Project Name: **PROPOSED COMMERCIAL DEVELOPMENT  
MARRIOTT STUDIORES HOTEL  
PARCEL ID NO. 26065-020-000  
SOUTH TYNDALL PARKWAY, PARKER, FLORIDA  
SUBMITTAL NO. 3 REVIEW**

**PUBLIC WORKS REVIEW COMMENTS:**

## PLANNING REVIEW COMMENTS

**26. Utilities:**

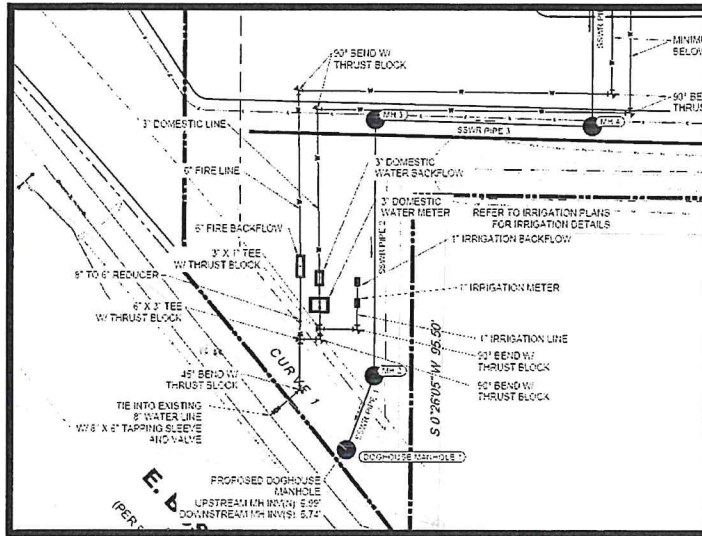
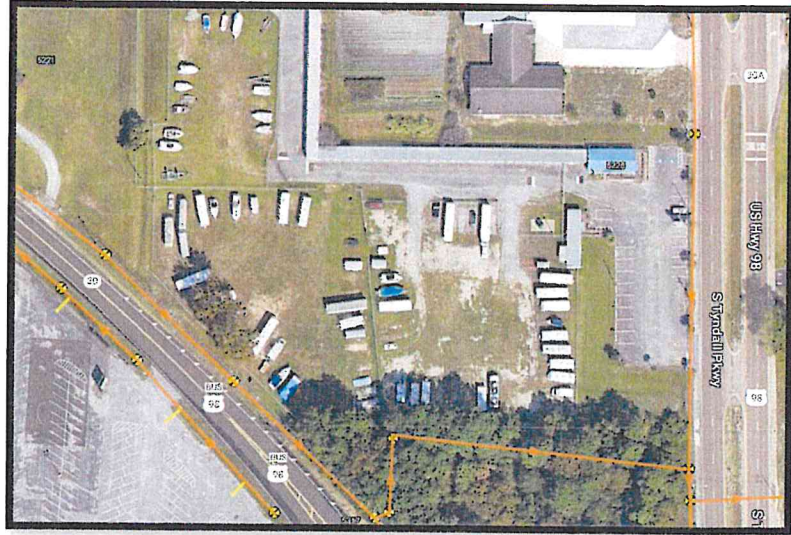
Applicant will need to connect to the City's 8-inch PVC Potable Waterline that runs in the rear of the parcel along U.S. Business Highway 98.

From the Utility Plan, it appears that the Applicant will tie into the 8-inch waterline with a 6-inch waterline that will branch out for a 6-inch fire line and backflow, a 1-inch irrigation line, backflow and meter, and a 3-inch domestic waterline that will route into the building with backflow and water meter. **Please contact the City for fees related to water meter and tap for this project.**

Applicant will need to connect to the City's 8-inch PVC gravity sewer main either along South Tyndall Parkway or U.S. Business 98 or the portion that cuts just south of the parcel that connects the two gravity sewer lines together.

From the Utility Plan, it appears that the Applicant will tie into the City's 8-inch gravity sewer along U.S. Business 98 with the installation of a doghouse manhole. The applicant proposes 7 manholes throughout the site. It is proposed that 358 linear feet of 8-inch PVC sewer piping will route through the manholes and into a cleanout at the hotel. **Please contact the City for fees related to sewer lateral installation for this project.**

City has been contacted for water meter and sewer tap fees.

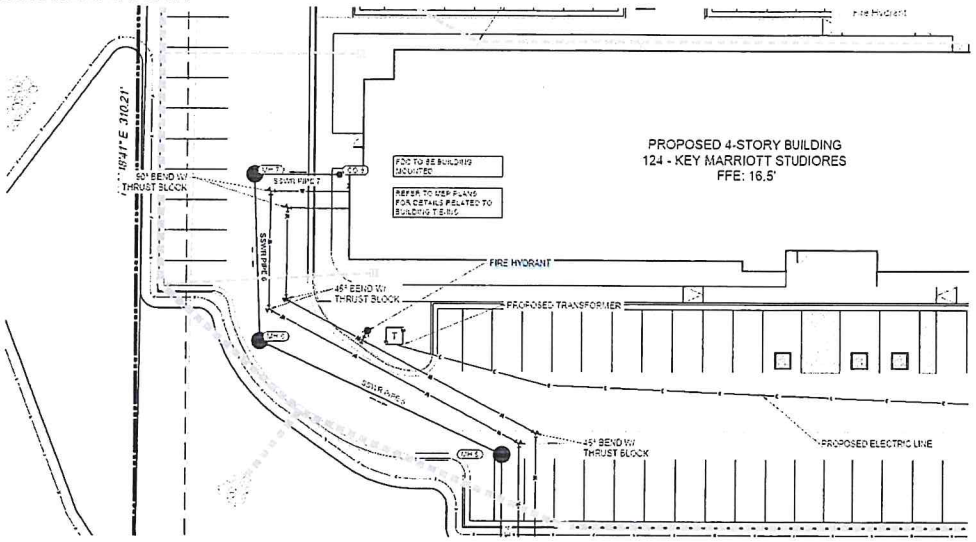
<p><b>Fire Hydrant:</b>                  Applicant proposes one fire hydrant to the south of the proposed building as indicated below.</p> 
<p><b>27. SubArea 3 – Commercial Intensive Parkway Overlay</b></p>	<p><b>APPROVED AS NOTED 11/25/2024:</b>  <i>Planning Review Comment 08/15/2024</i>                  As referenced in Article 4-7.4 – Subarea 3 – Commercial Intensive (South Tyndall Parkway / Highway 98), Applicant shall show compliance with the overlay design standards and the City’s vision for this area of Highway 98:</p> <ol style="list-style-type: none"> <li>1. Building Architectural Style – The use of a common set of colors and building materials should be maintained for building facades to create a consistent and traditional architectural identity. Variations in roofline, façade, and depth should be provided.</li> <li>2. Building Use Mix – Non-residential mixed-use buildings are desired fronting Tyndall Parkway.</li> <li>3. Pedestrian Mobility – All properties within the subarea are encouraged to provide sidewalks parallel to public rights-of-way across the entirety of the property frontage and connecting with and to existing sidewalks located on abutting properties. Internal sidewalks are also encouraged to provide linkages to building entrances.</li> <li>4. Parking – Parking standards will meet the requirements of Section 5-9 Traffic Circulation and Parking. The parking in front of the buildings should be limited to create an urban form where buildings are closer to the street and parking is in the rear.</li> <li>5. Streetscape and Landscape – The parking lots shall meet the landscape requirements as set forth in these Land Development Regulations. The streetscape will be encouraged to include wider sidewalks, street trees, median plantings, and landscaped buffers of parking lots.</li> </ol>
